Product Change Notification

PCN #: 5A-2018

DATE: 10th May 2018

Rev 1,2 – 2 screws

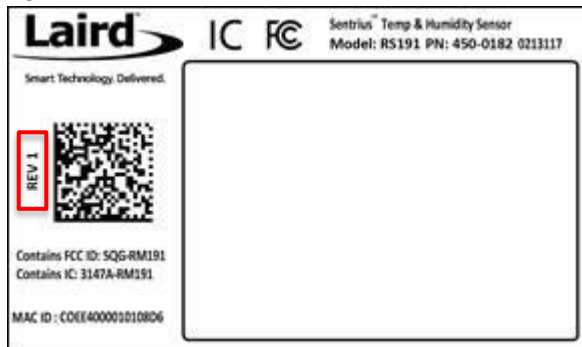
- Base/battery cover changes – applied to all variants

Current Rev 7 – 4 screws

Rev 1

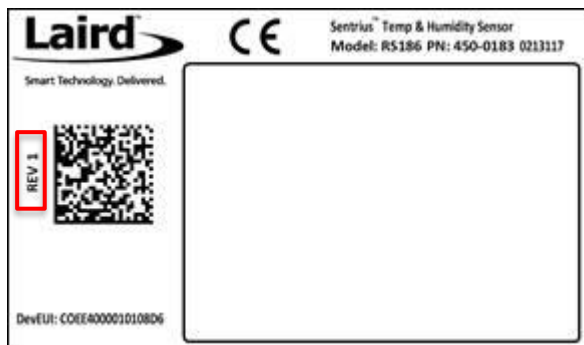
- Labelling Changes – 450-0182

Current Rev 7
